To: Jerry Rigby
Fremont Madison Irrigation District
Madison Ground Water District
RMEA project 11-0068

Fr: Bryce A. Contor

Date: 20 June 2011

Re: Proposed boundary changes to Conjunctive Management Rule 50

Figure 3. Spatial distribution of modeled effects of pumping or curtailment of FMID and MGWD irrigated lands within the change area.

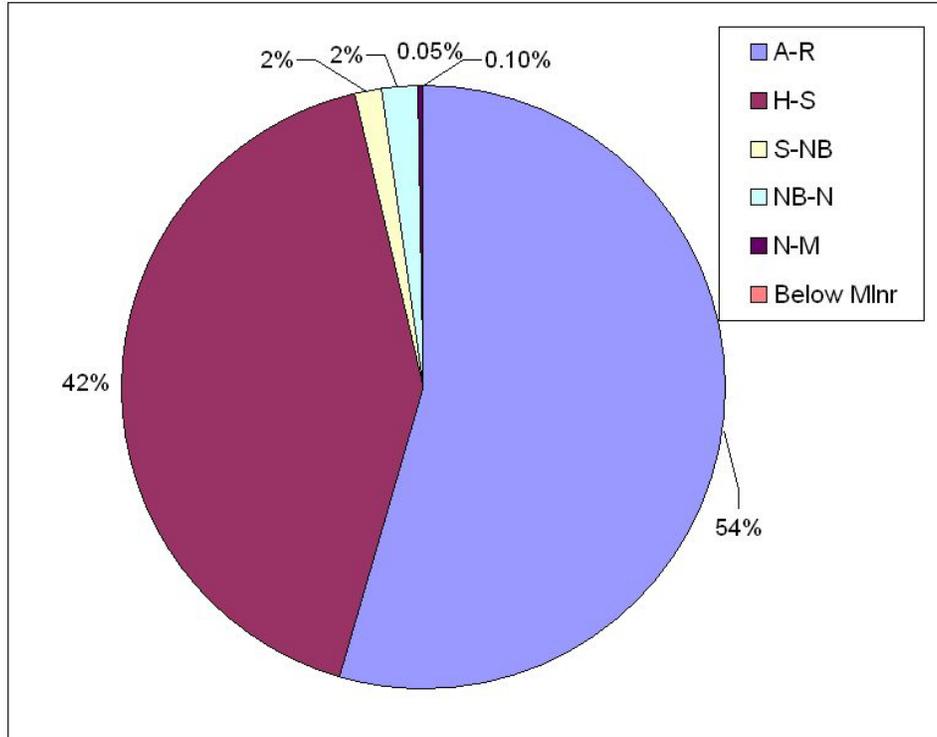
Figure 3 illustrates the modeling result that nearly all (96%) of the effect of pumping (or potentially of curtailment) propagates to the Henrys Fork or the Snake River above Shelley. This means that as long as the 10% rule of administration is applied, these are the only river reaches where a water call may potentially affect the proposed change area in FMID and MGWD. The model indicates relatively rapid propagation of effects to

the Henrys Fork and Snake River above Shelley, with more delayed arrival of the small effect that is estimated to reach other locations.

Figure 6. Location of two wells south of Rexburg, one on either side of the toe of the bench. The background gray hill-shade is based on land-surface elevation.

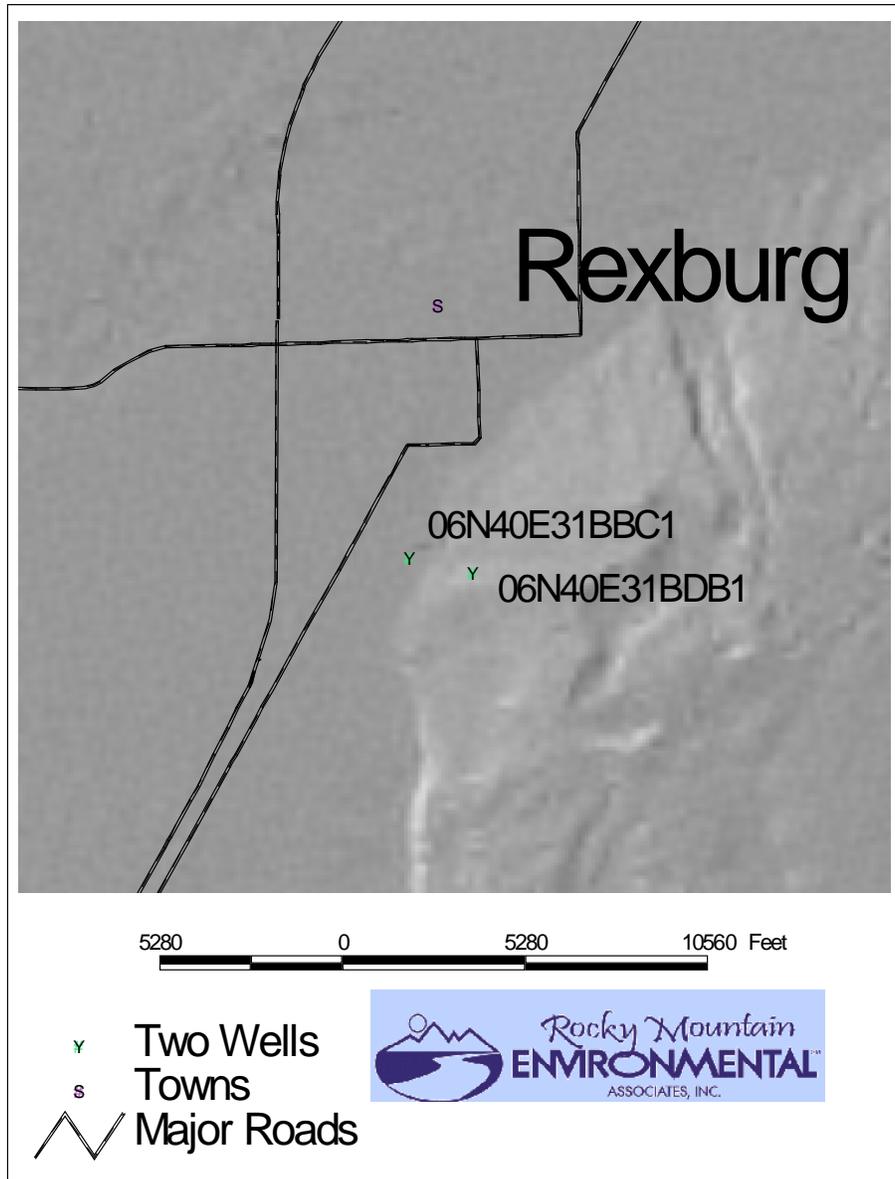
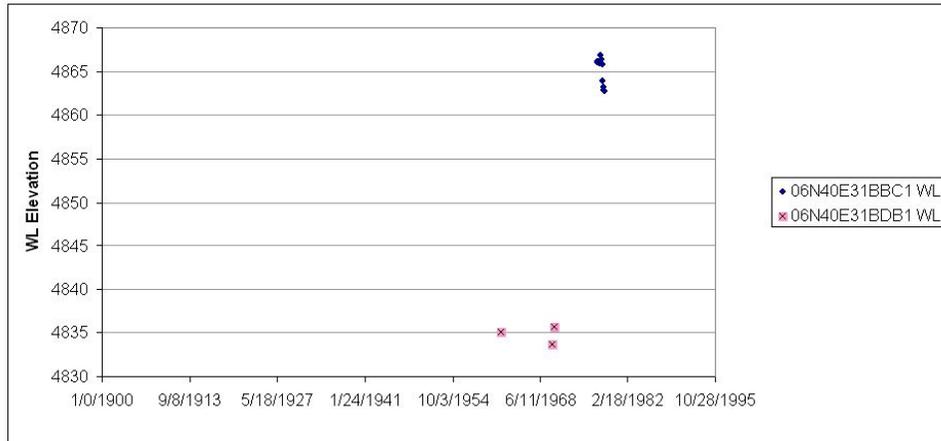
Anecdotal reports suggest that faulting on the toe of the Rexburg bench forms a hydraulic discontinuity that results in significant differences in water levels across a relatively short distance. Figure 6 illustrates two wells south of Rexburg, one on either side of the toe. Water level data are shown in Figure 7, with the bench well having lower water-level elevation.

Lithology was not obtained for these wells. However, USGS data sheets indicate the top of the the east well (06N40E31 BDB1) is at an elevation of 4,937 feet, completed to an elevation of 4,801 feet. The top of the west well (06N40E31 BBC1) is at 4,885 feet, completed to an elevation of 4,835 feet.

The difference in water-level elevation across such a short distance is consistent with a conceptual model of hydrology dominated by surface-water irrigation on the west, hydrology dominated by groundwater irrigation on the east, and a low-permeability barrier such as a fault zone between the two wells.

Figure 8. Water-level data ("ESPAM1 Targets") used to calibrate ESPAM1.1.

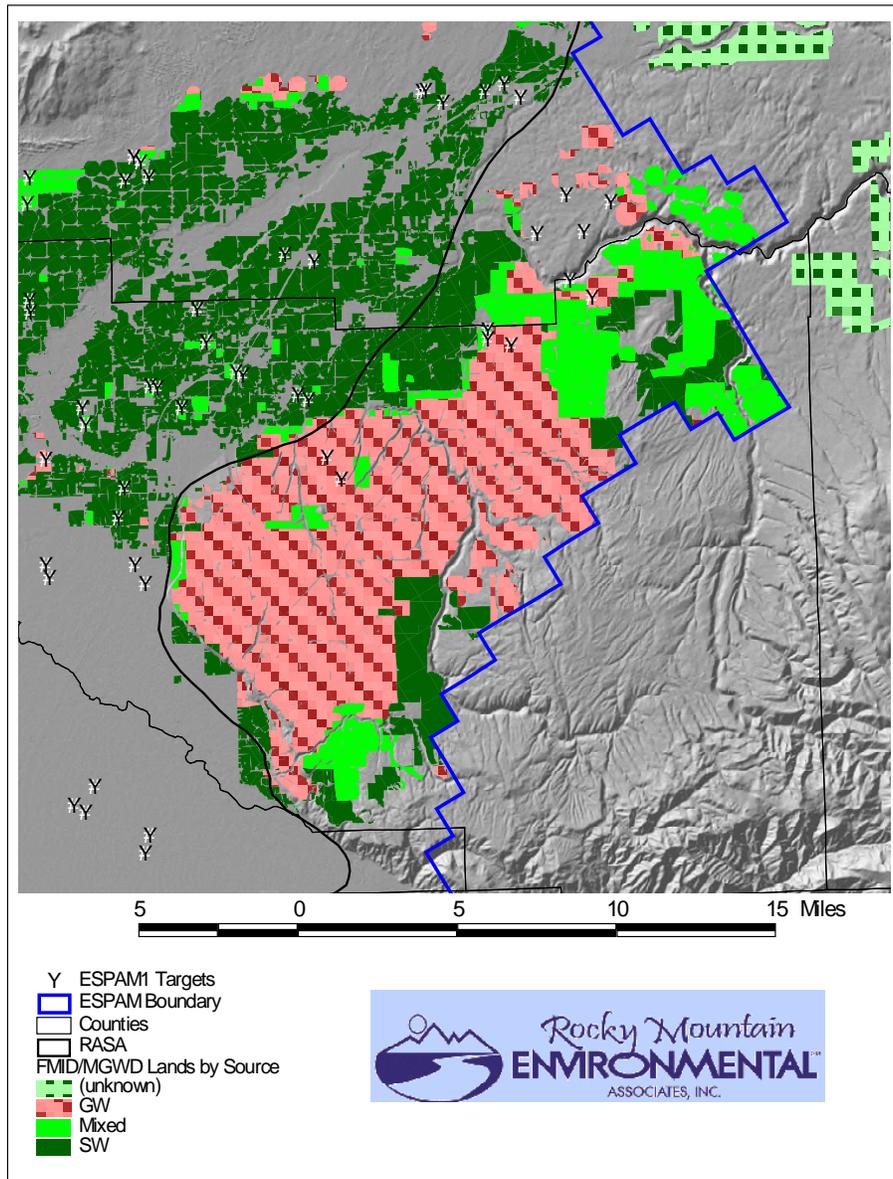
Inadequacy of Data. Though hard to see, the small dots on Figure 5 illustrate the water levels that Haskett relied upon in his evaluation. These pre-date the ESPAM1.1 modeling period by nearly a decade. Figure 8 shows that far fewer data were available to constrain the calibration of ESPAM1.1.

Figure 9. Pilot points for estimation of aquifer transmissivity in ESPAM1.1.

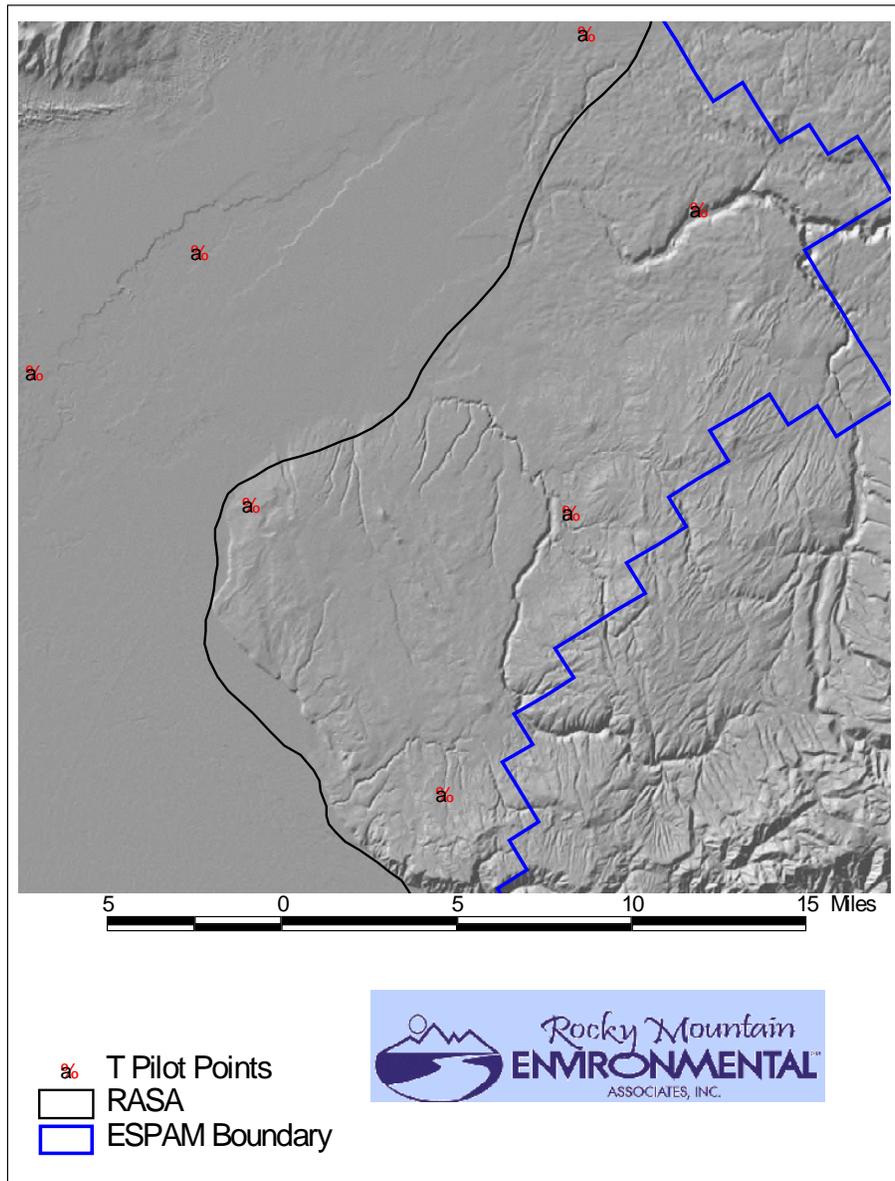
The zone methodology best represents reality where faults or geologic facies exist. This would be appropriate, for instance, for representing the boundary between the Rexburg Bench and the aquifer proper. The pilot point approach best represents broad expanses of similar materials, where gradations in characteristics occur over some distance. This would be appropriate for representing the body of the Snake Plain Aquifer. While pilot points may be concentrated to represent regions where properties are believed to change over short distances, computation limitations hinder the total number of points that may be used.

Pilot points were used in ESPAM1.1. To date, administration calculations have been steady-state or long-run calculations. Transmissivity is the property that governs these calculations. Figure 9 shows the spatial distribution of points for representing aquifer transmissivity. Storage-coefficient pilot points are even more sparse.
